City of Chipley

Development Order Application
The property is located at 1621 Main Street, Chipley, Florida and is in the Commercial zoning district. The purpose of the review is to identify whether the proposed development is consistent with Part II of the City of Chipley Code of Ordinances. Deficiencies of the applications are indicated in red throughout this memo based on the application materials provided. The applicant has sufficiently addressed all comments. There are some additional permits and documentation that will be required to be submitted once received as noted throughout in **orange**.

SITE PLAN FOR PICKUP EXPANSION

SHEET:
C1.2

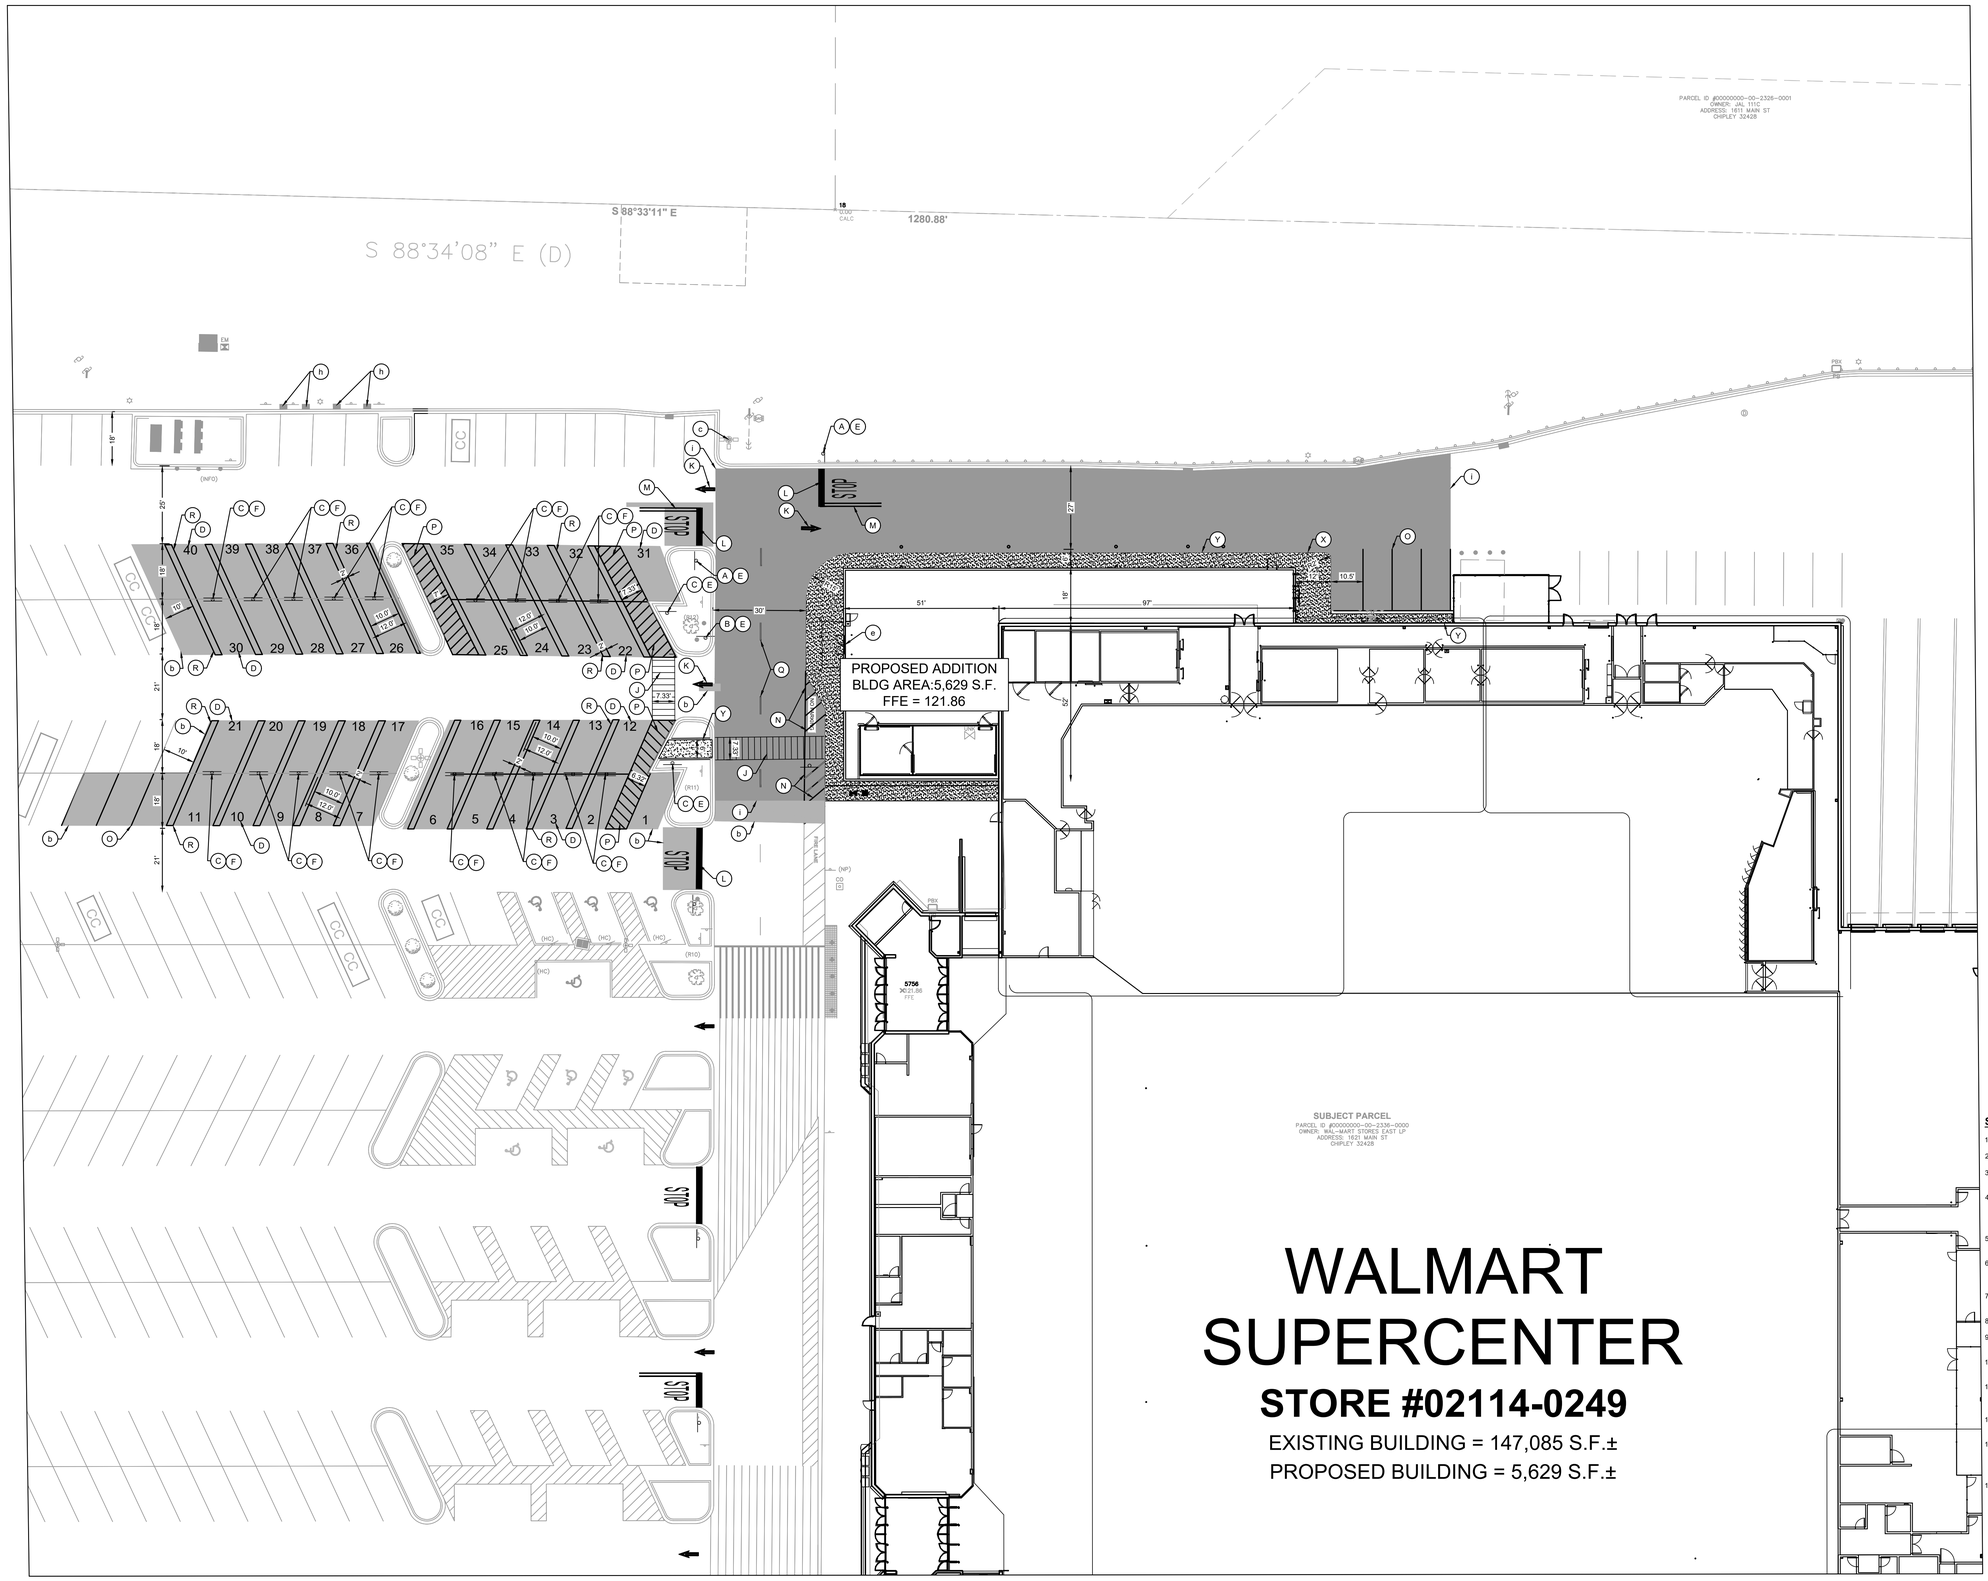
Sufficient: The proposed front setback is 700 feet, according to Plan Set Sheet C1.2. **For commercial zoning there are no side and rear setbacks are required.**

SHEET: C1.4

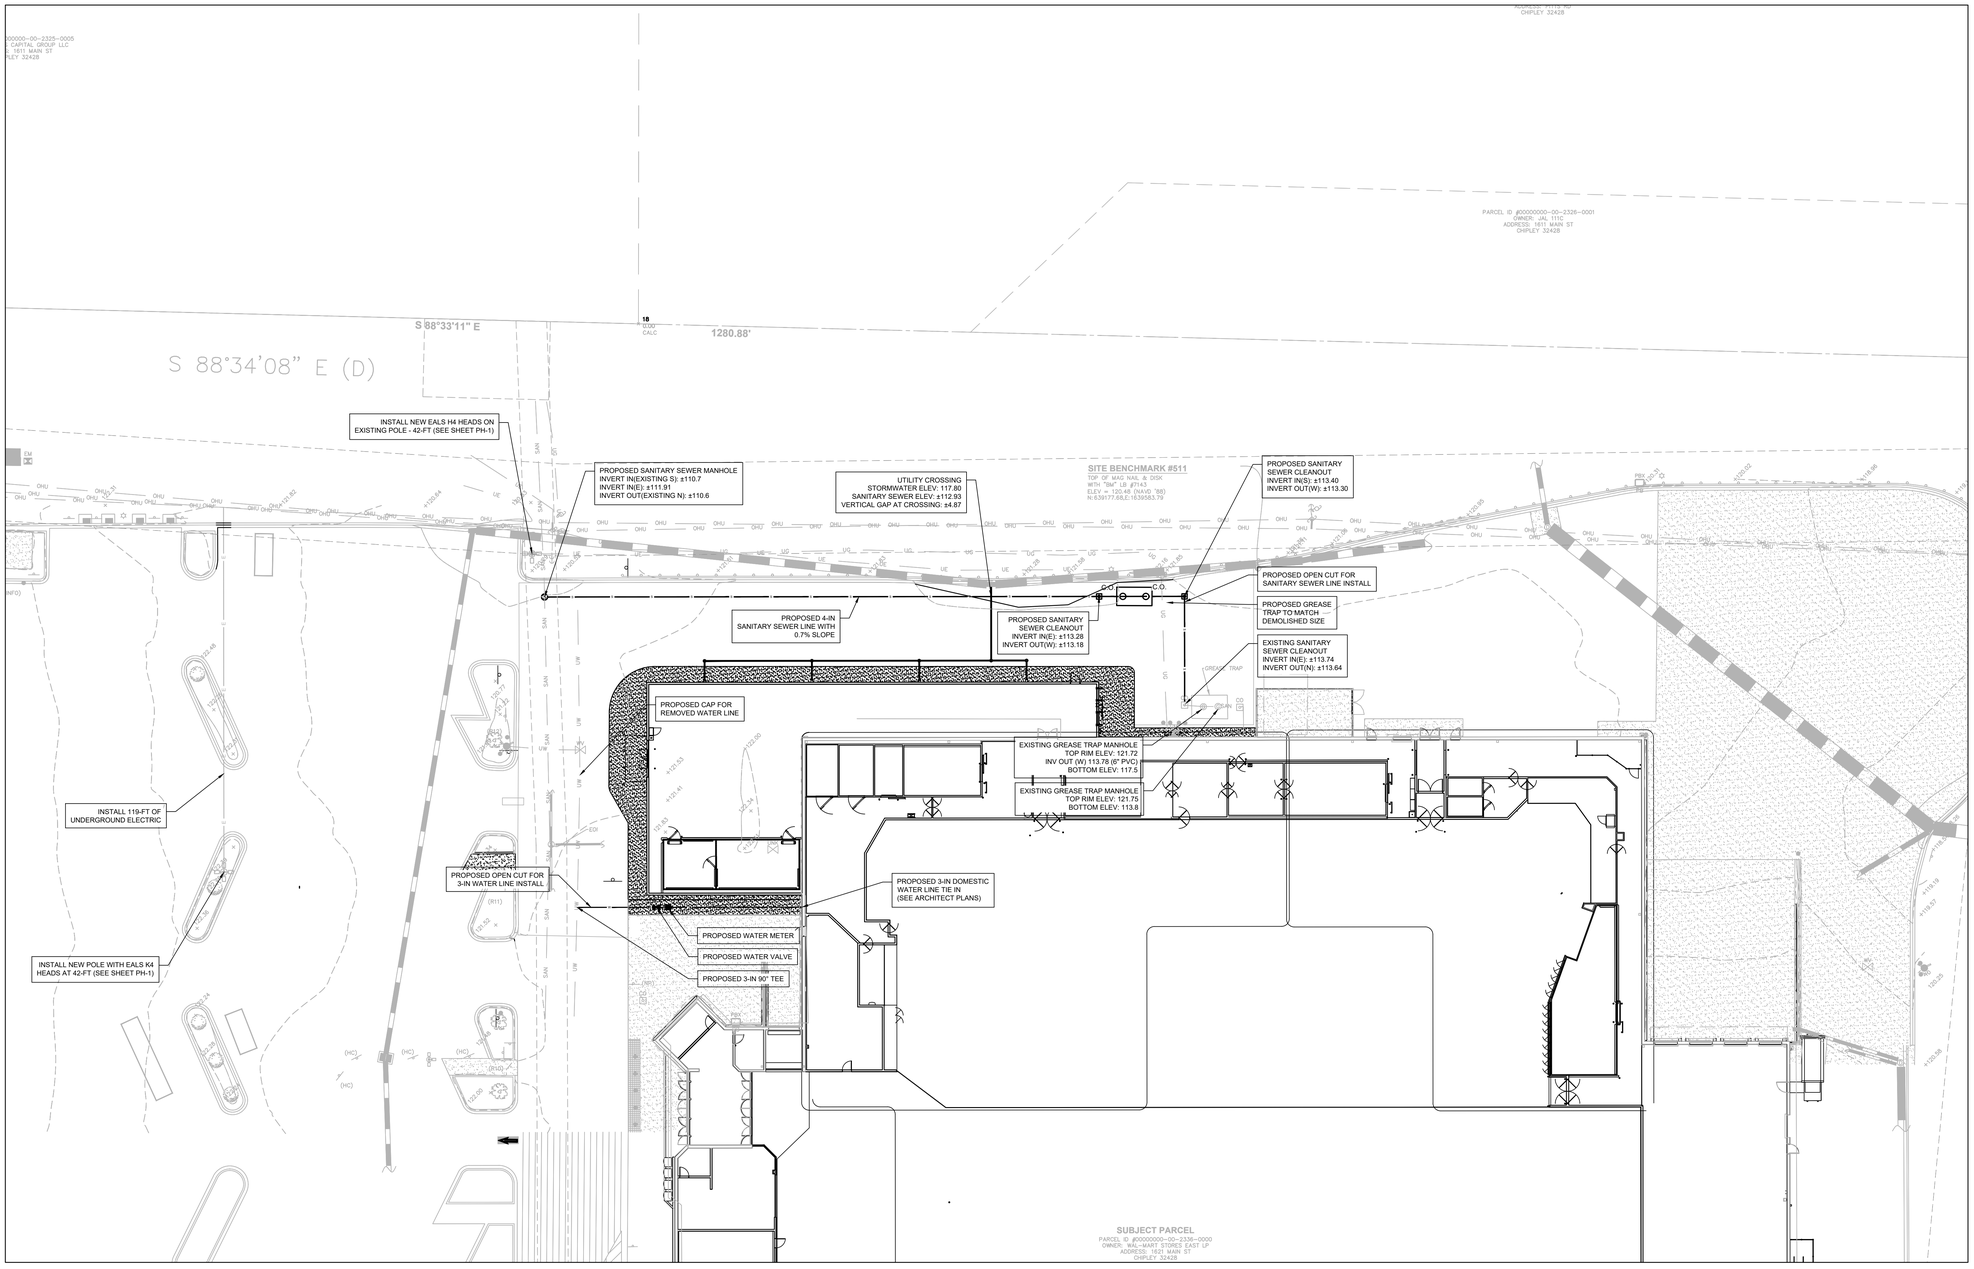
Sufficient: Provided in Plan Set: Sheets V1.2 & C1.4

SHEET:
C1.5

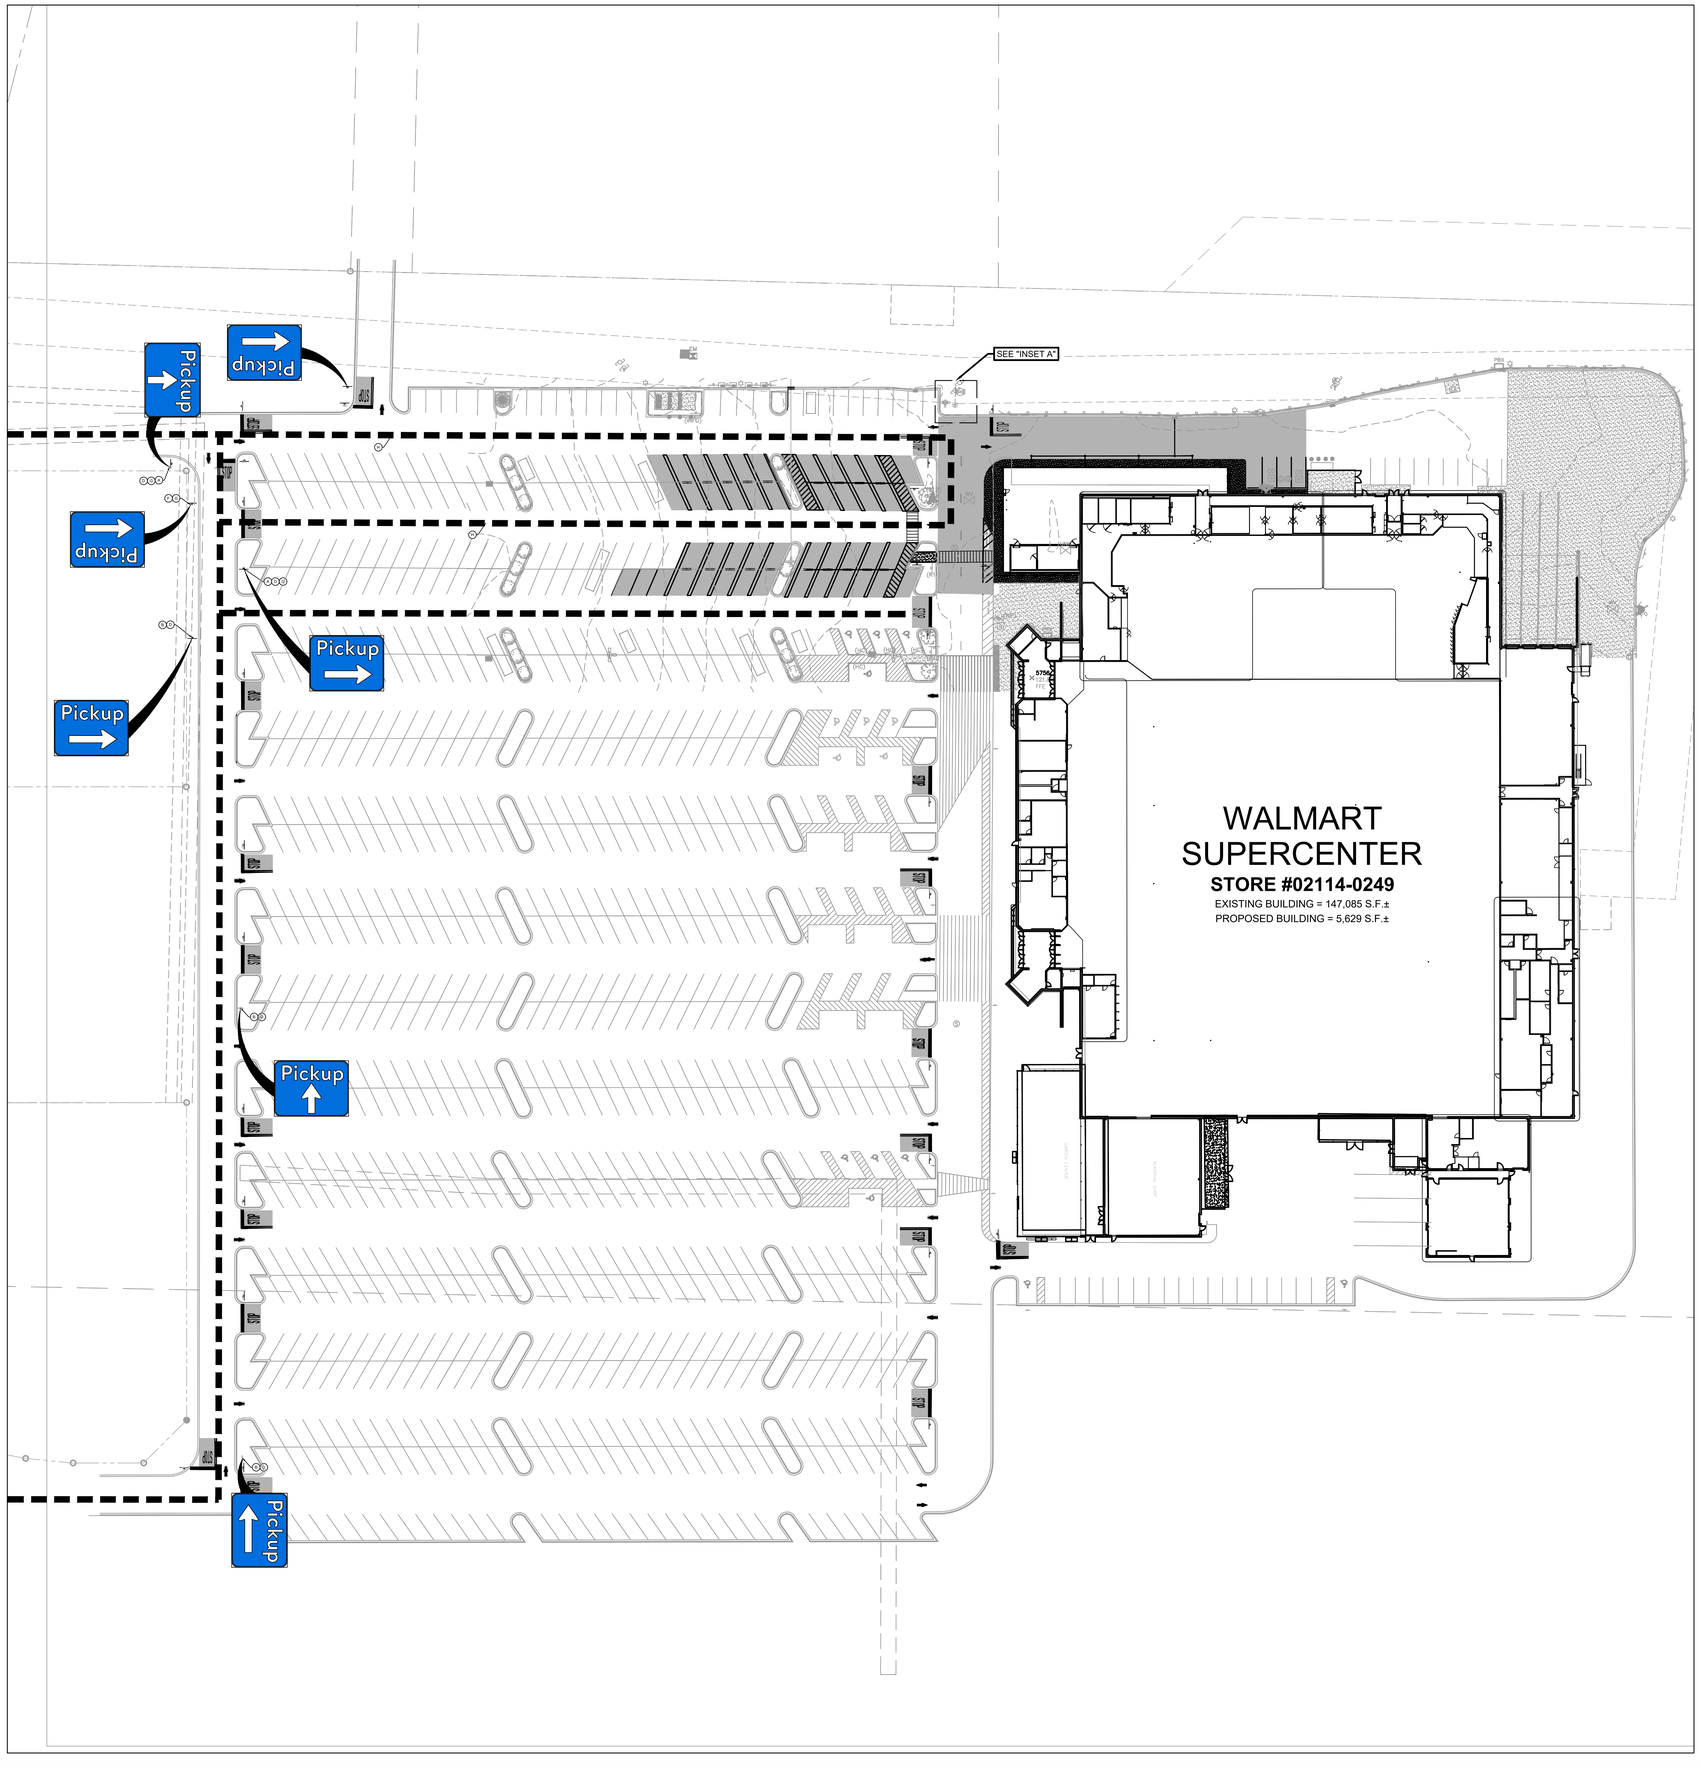
Sufficient: Provided in Plan Set: Sheet V1.1 & V1.2 & C1.5.
